3 October, 2018

**Objection to State Significant Development 8922 (SSD 8922)  
Major Alterations and Additions to Stevenson Library  
Scots College, Victoria Road, Bellevue Hill**

**Figure 6: Panoramic view from swimming pool**

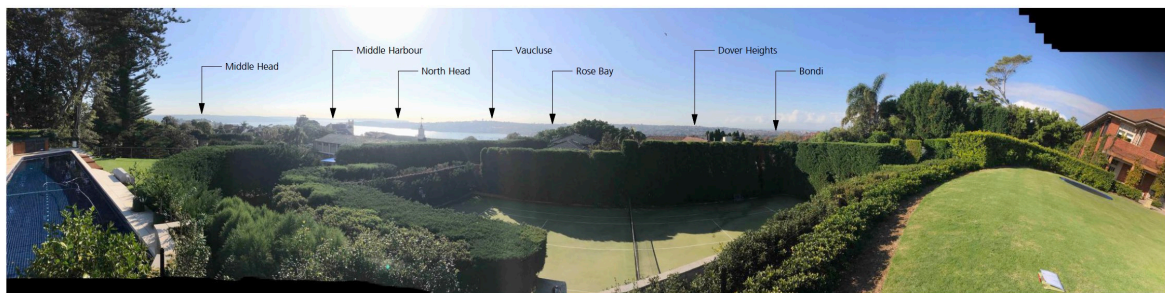
Figure 6 above provides a dramatic representation of the loss of water views and partial landform views due to obstruction by the proposed development. The before image provides a largely unobscured whole water view from Rose Bay to Middle harbour. This uninterrupted view, with the exception of the punctuation by the Middle School clock tower, is highly valuable to the property and its history. Further, it is visible from a sitting or standing position from any portion of the outdoor grassed area.

The after image shows the intrusion of the proposed building effectively halves the expanse of water view from Rose Bay to Middle Harbour.

**Figure 4 – Eastern elevation of the current library - viewed in context from the oval**

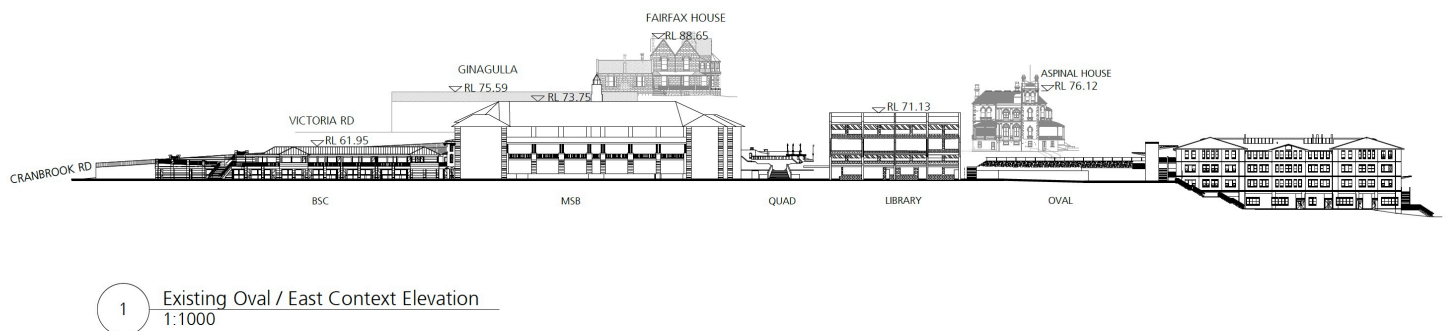
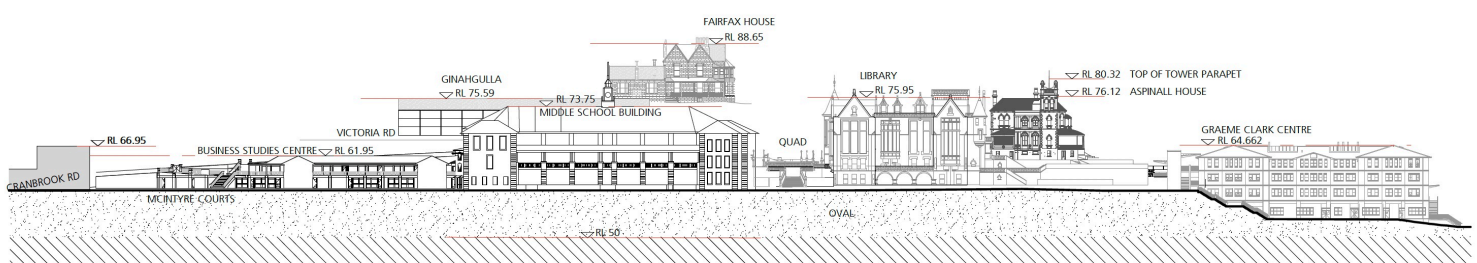
A simple visual comparison between the existing and proposed building shows the increase in dimensions (width and depth) and architectural elements that will punctuate the skyline

– features which, when viewed from the higher vantage point of our client's property appear to be even more prominent.

**Figure 7: Southern elevation – proposed building superimposed over outline of existing building**

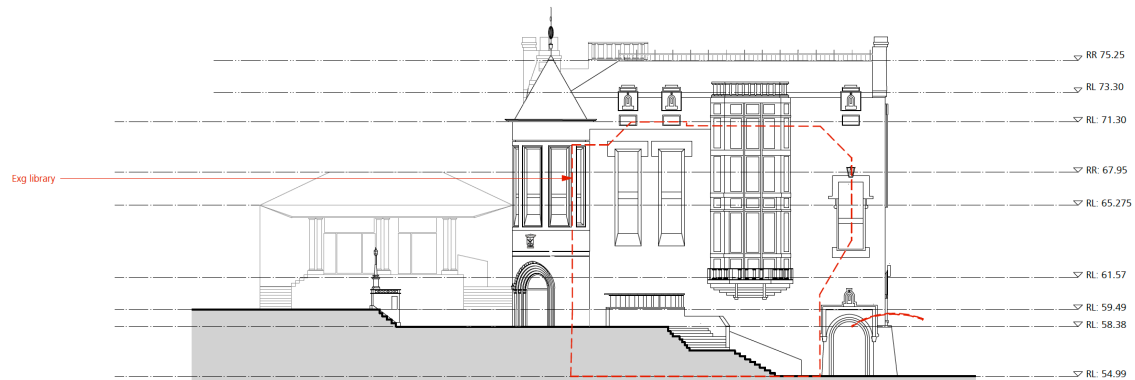
The substantial increase in the building's dimensions explains the dramatic impact that the proposed building has on views from Barford.

**Figure 9: View Analysis Photo**

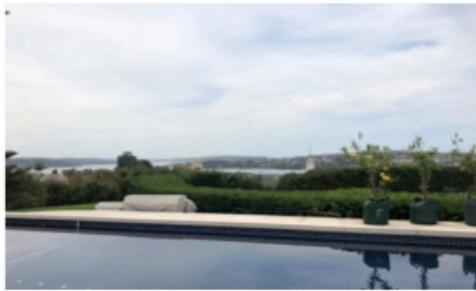
We note that this exercise has been undertaken in the Applicant's View Analysis. However, it would appear that the vantage point from which photos forming the basis of analysis are taken (View Point 20 – Page 41) inadvertently understates the value of the views presently available. Accordingly, we provide the following Figure 9 which captures the view from a height closer to standing eye height associated with normal use of the space.

From Figure 9 above, we would describe the clock tower and Aspinall House as providing a frame around the interface of Vaucluse land mass and Rosebay. East of Aspinall House the view is essentially uninterrupted. The clocktower can in fact be described as a positive contribution due to its iconic nature and landmark status.

What is proposed is a significantly more bulky building which will remove what is presently a framed, iconic and heritage significant view.

Given that other (but more distant and / or angled) water views are retained we would not describe the view impact as devastating. However, relative to the significance that the existing views have for Barford, the near total loss of the most central and framed portion of the property's view is a severe impact.

**Figure 10: Montage of Sitting View Locations within Barford**

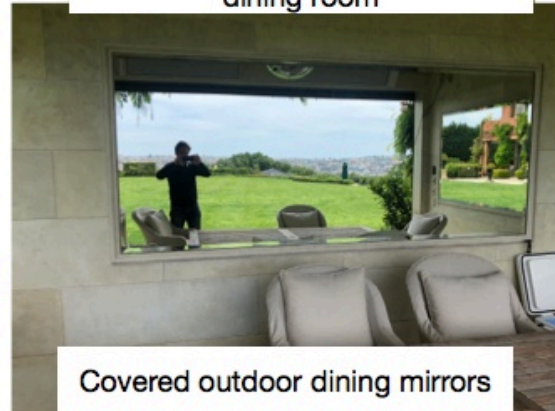
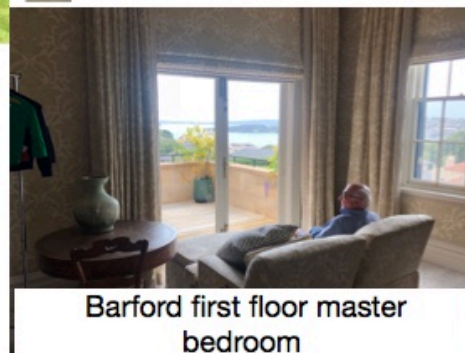
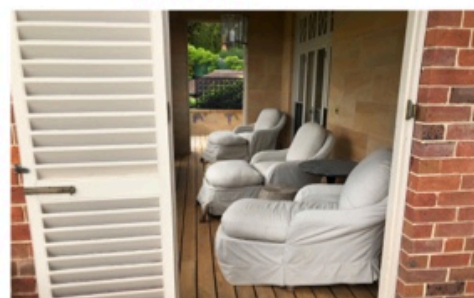
The view which will be impacted if from the primary indoor and outdoor living areas of Barford and the primary indoor living area of the 3 bedroom flat. Both standing and sitting views are affected.

Whilst it is acknowledged that sitting views are more difficult to protect, the particular characteristics of the open space of Barford employ numerous intentional areas for sitting. These include the covered garden dining area, the pool side area and the terraces and balconies. The following montage shows view available from each of these areas. So significant are sitting views to the enjoyment of the open space areas that the covered

outdoor dining room is lined with mirrors on all walls to enable the views to be appreciated from all table sitting positions.
